SOUTHBAY LOGISTICS CENTER

TAC Case No.: 2203-26
Project Address: 4000 Via Oro Ave

SUBJECT: TECHNICAL ADVISORY COMMITTEE – BUILDING AND SAFETY

Subject: In Lieu of Technical Advisory Committee
Application No.: 2203-26 (SPR22-036)
Project Location: 4000 Via Oro Ave.

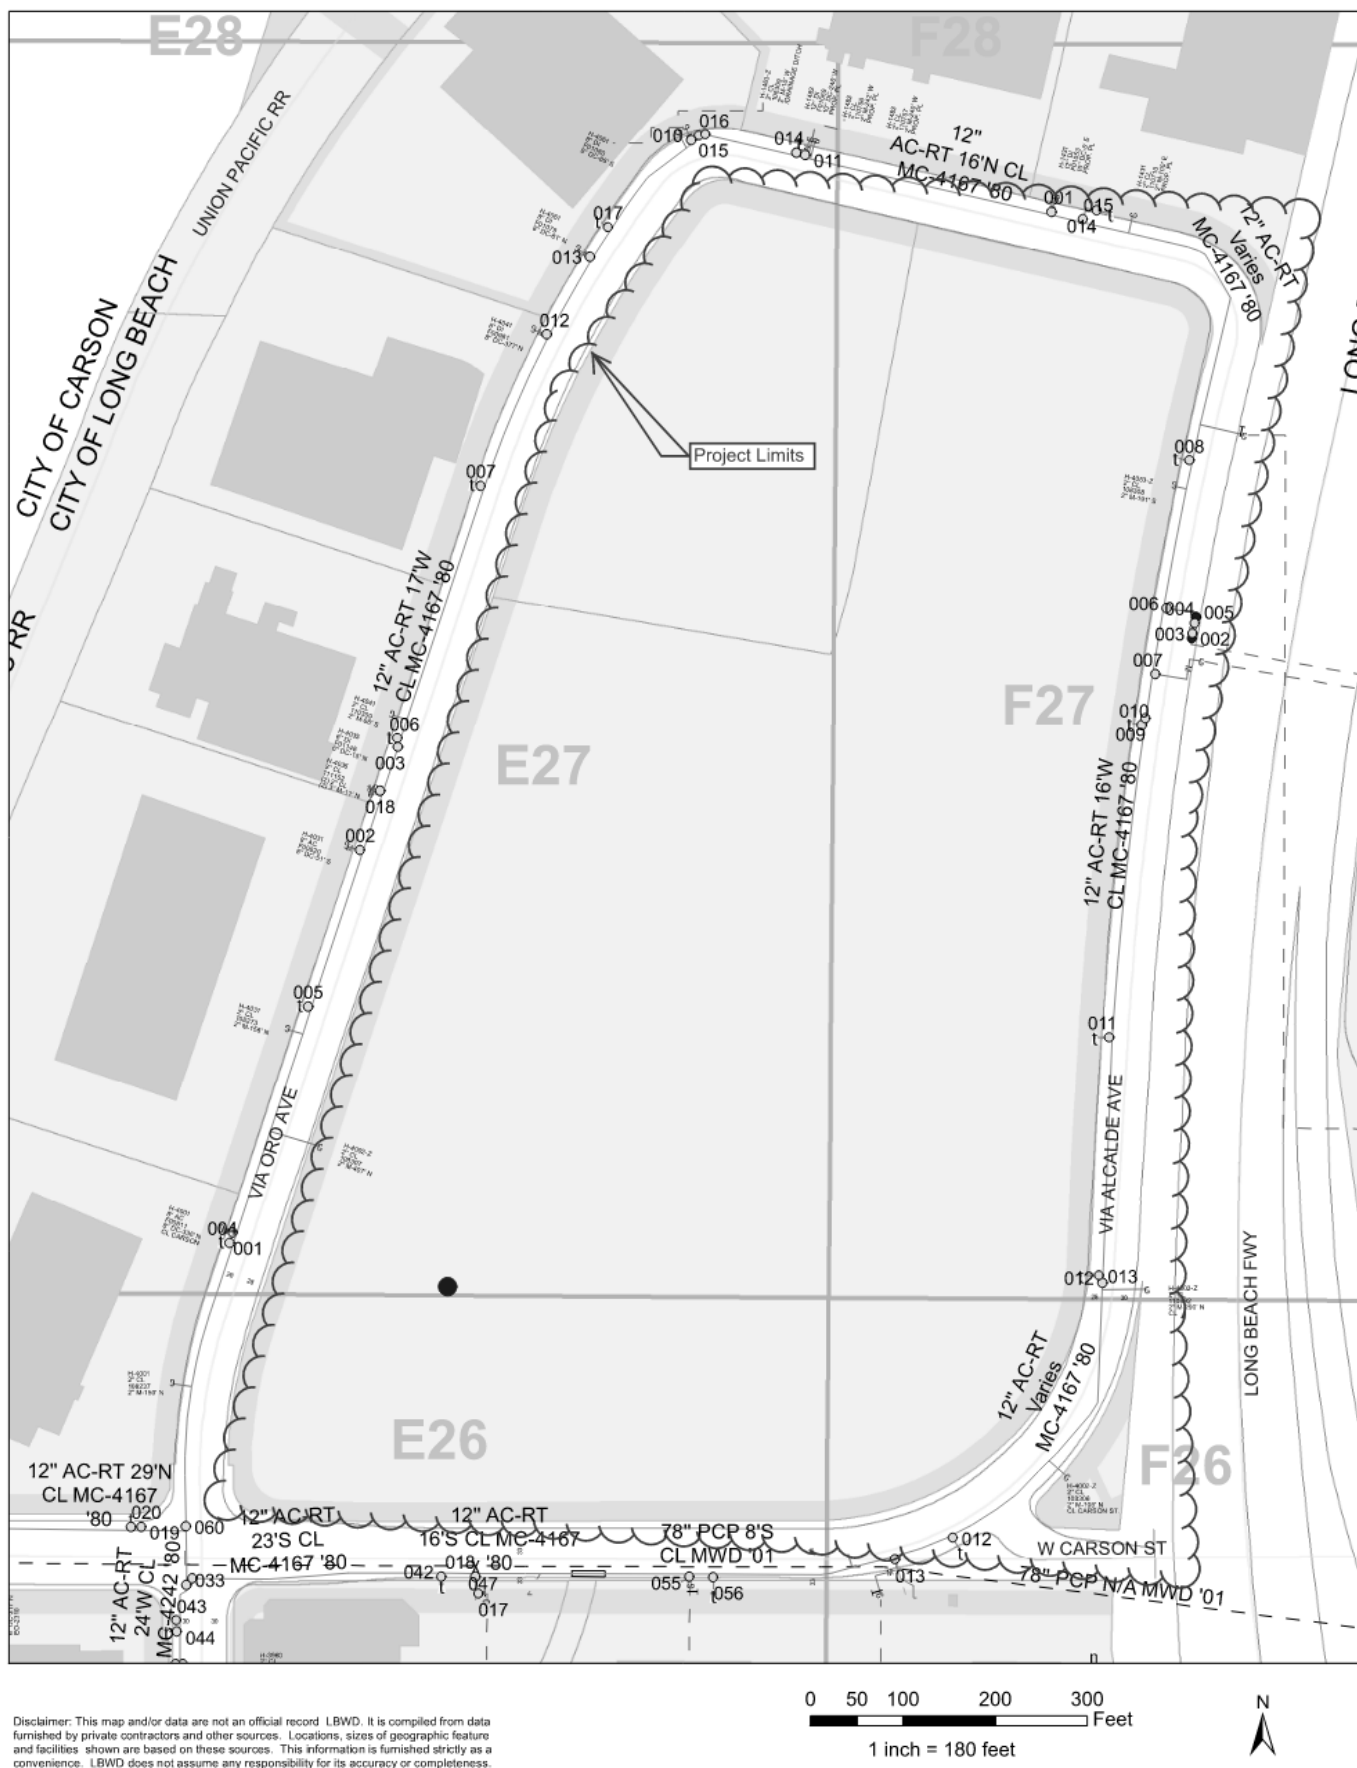
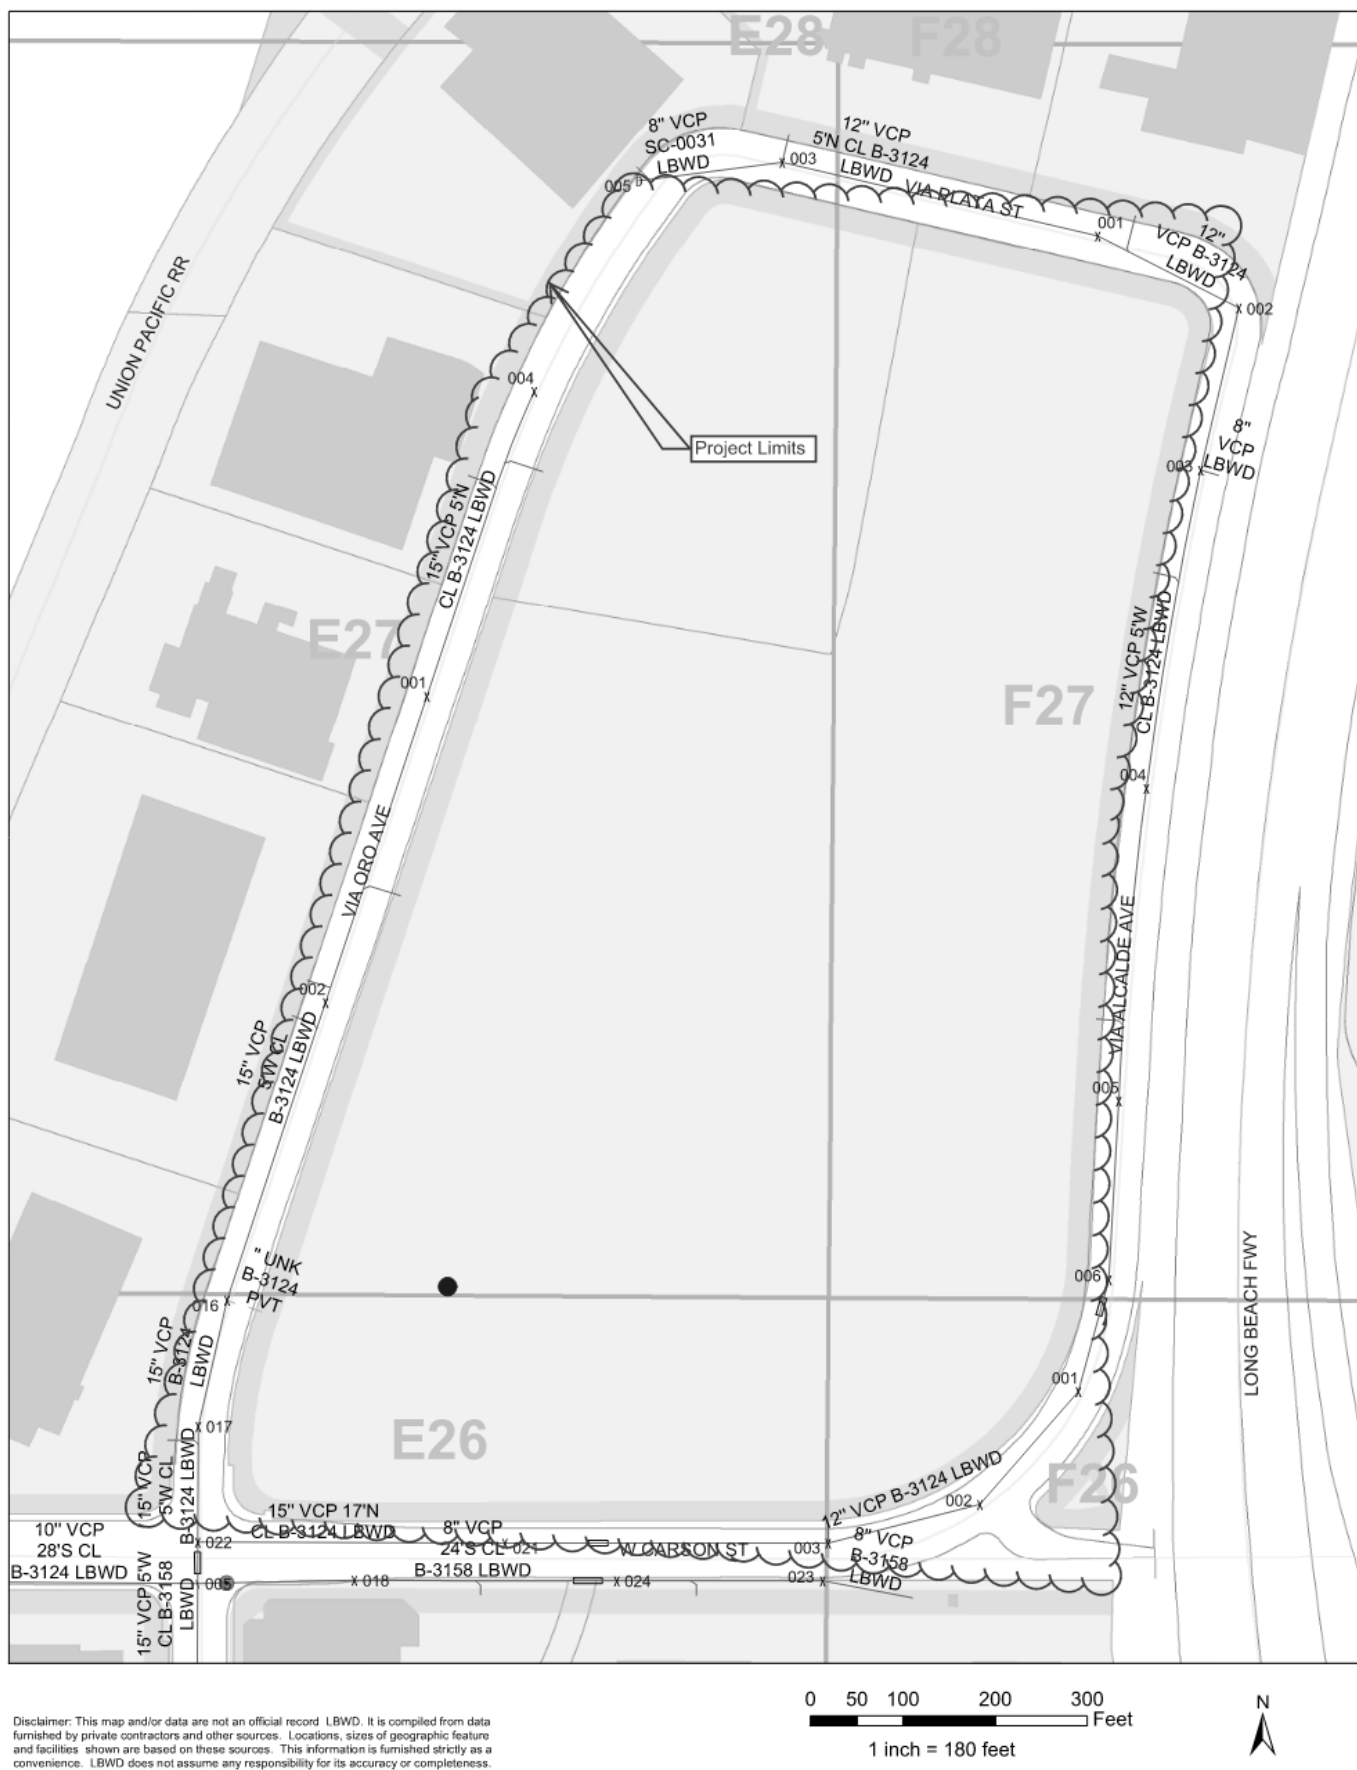
Water Mains:
According to our records, the following water mains are present in the streets adjacent to the project site:

Street / Location Description	Main Size (inches)	Main Material
W. Carson St.	12	Asbestos Cem. Ring Tile (AC-RT)
Via Oro Ave.	12	Asbestos Cem. Ring Tile (AC-RT)
Via Alcalde Ave.	12	Asbestos Cem. Ring Tile (AC-RT)
Via Plata St.	12	Asbestos Cem. Ring Tile (AC-RT)
W. Carson St.	78 (Owned by MWD)	Prestressed Concrete Pipe (PCP)

Note: Water service connections may only be made to water mains 12 inches and smaller.

Water Services:
Please note, several existing water services are installed to the property; the property owner is responsible to order a kill tap for any unused water service laterals prior to start of construction.

Backflow Assembly Requirement:
Backflow prevention assemblies shall be required on this service. The device shall be located on private property. "A reduced pressure principle backflow prevention device shall be located as close as practical to the user's connection and shall be installed a minimum of twelve inches (12") above grade and not more than thirty-six inches (36") above grade measured from the bottom of the device and with a minimum of twelve inches (12") side clearance." (17 CA ADC § 7603)

Street / Location Description	Main Size (inches)	Main Material
W. Carson St.	15	Vitrified Clay Pipe (VCP)
Via Oro Ave.	15	Vitrified Clay Pipe (VCP)
Via Alcalde Ave.	12	Vitrified Clay Pipe (VCP)
Via Plata St.	12	Vitrified Clay Pipe (VCP)
Via Plata St.	8	Vitrified Clay Pipe (VCP)
